## **ADDENDUM # 1**

**RE:** Turbeville Branch Library  
Turbeville, S.C.  
CGD Project No. 22067

**DATE:** September 19, 2025

LEVEL 1 FLOOR PLAN

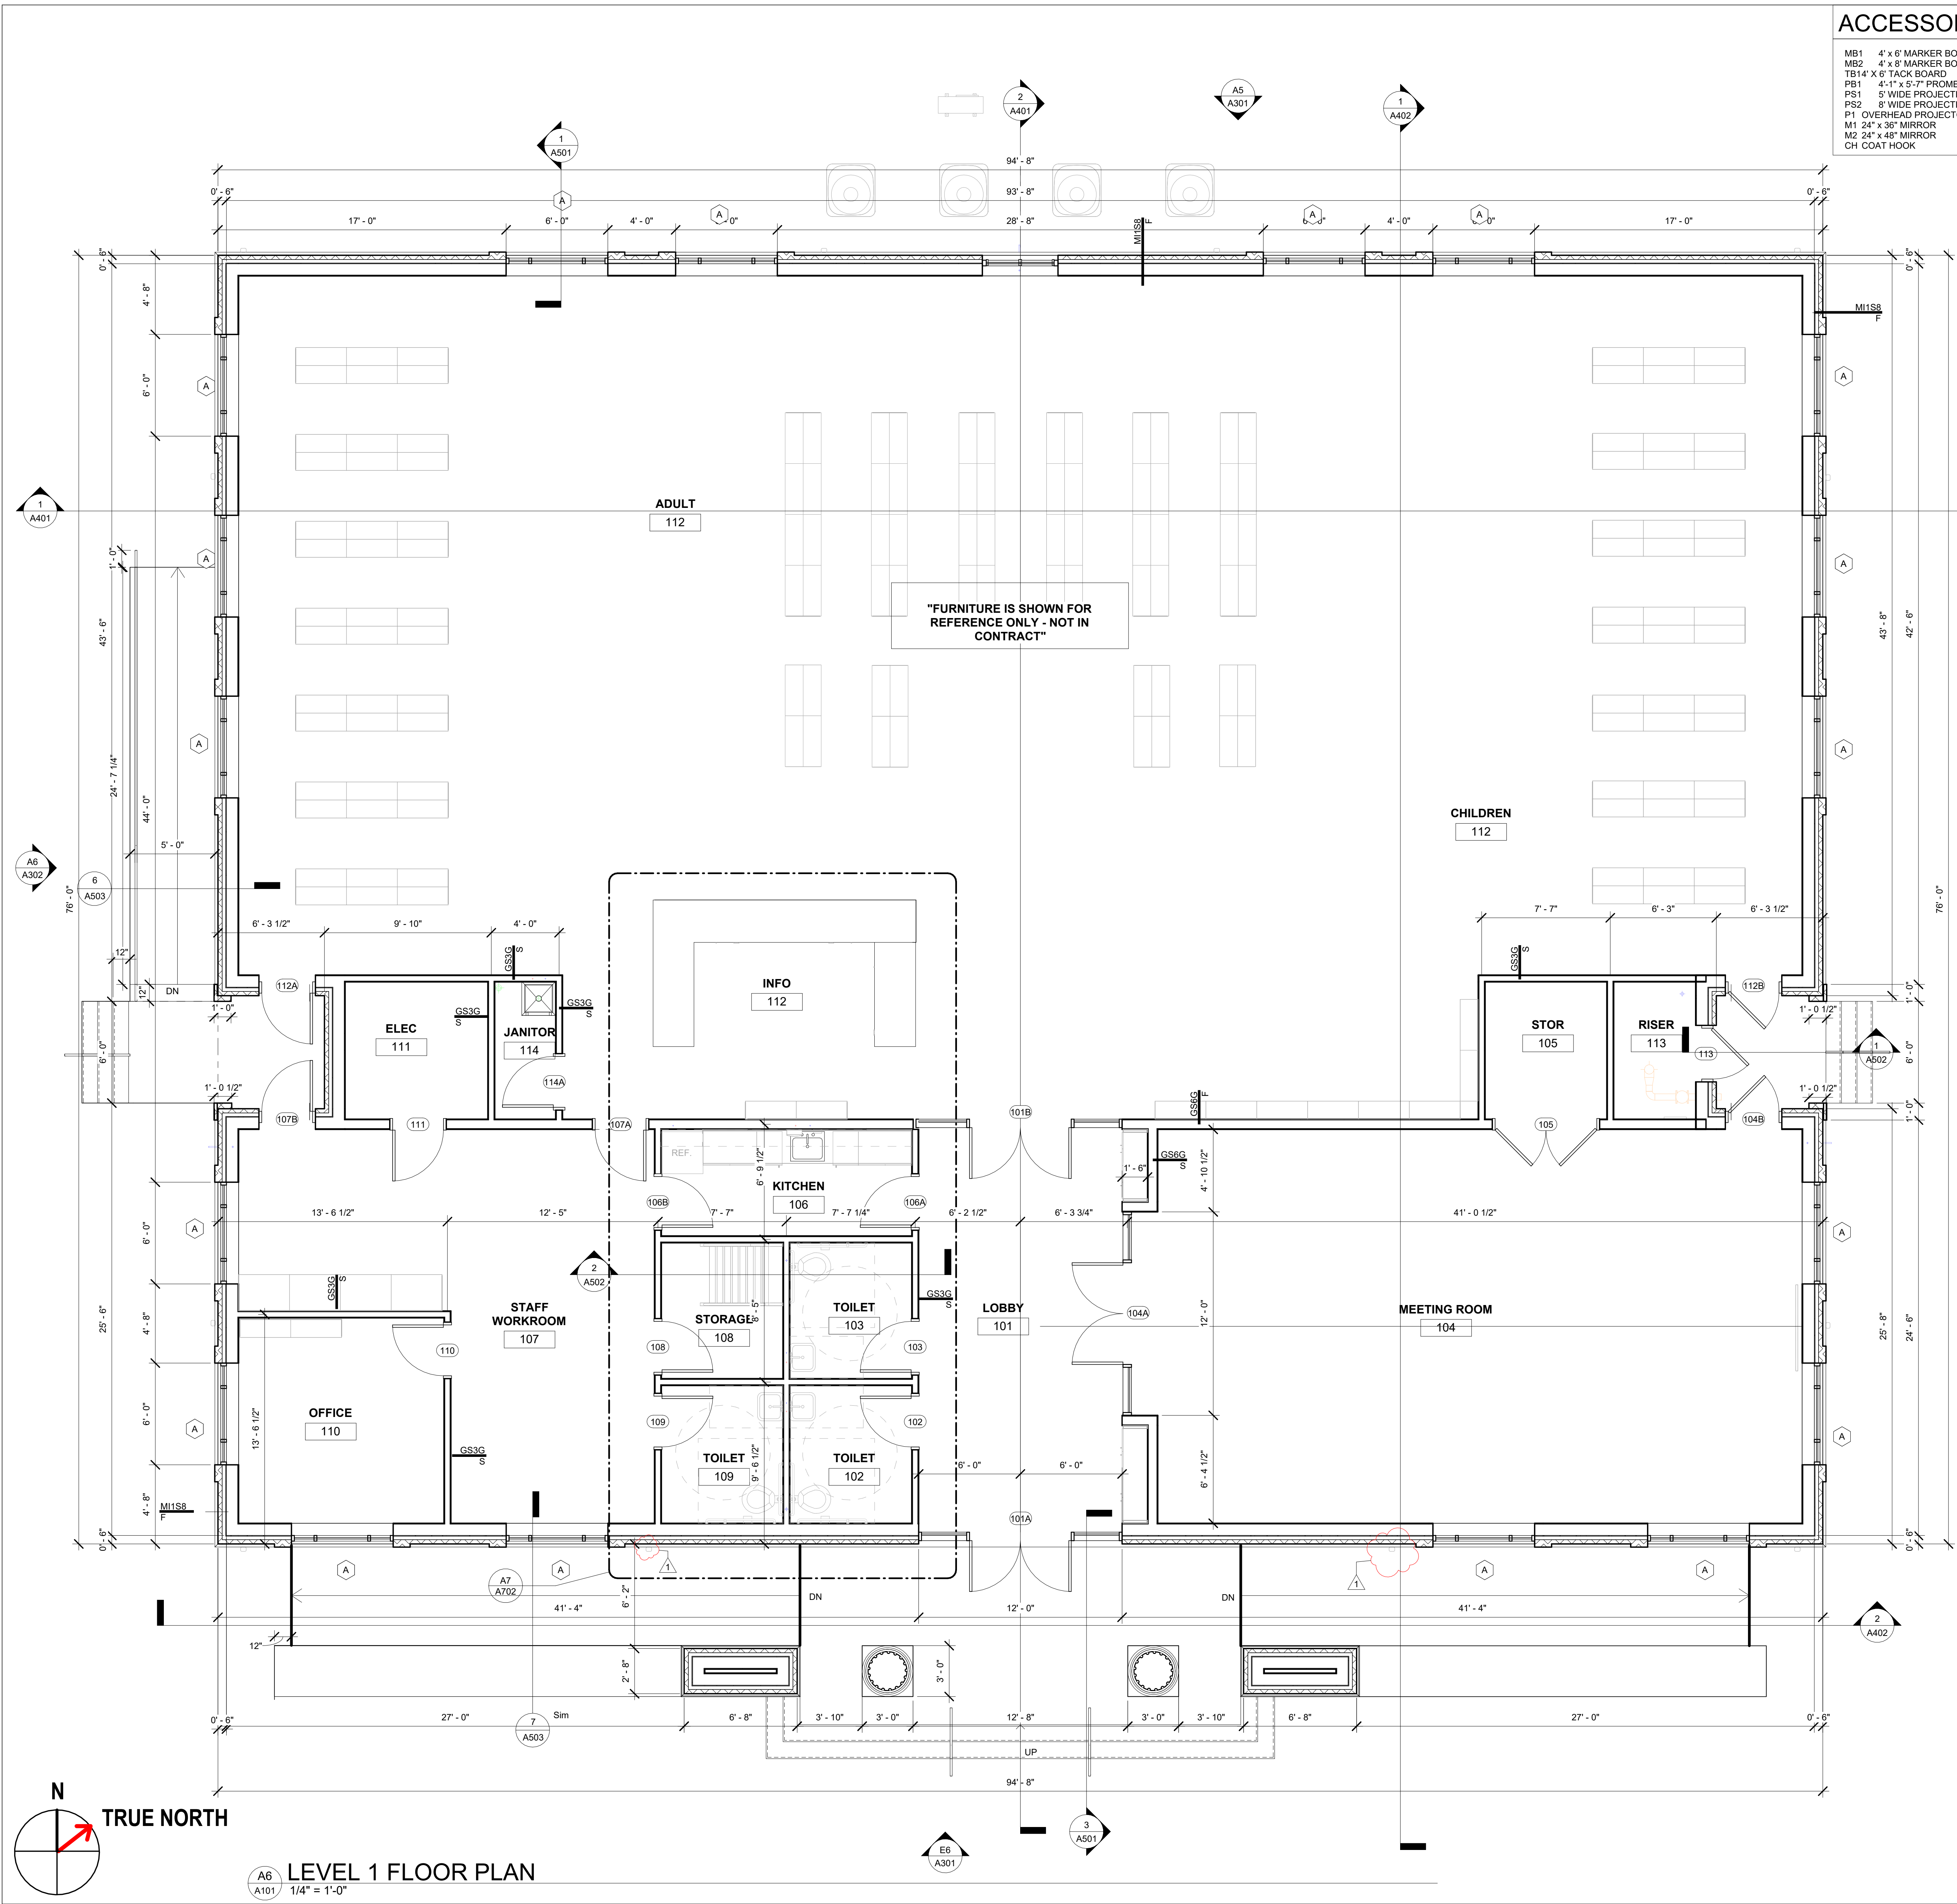
**D2    Sheet A101, A201, A301, A302, A401, A501, A502, A503, A601, A801:**

See clouded drawing revisions, noted as Mark 1, dated 9/17/25. All revised sheets are attached to this addendum.
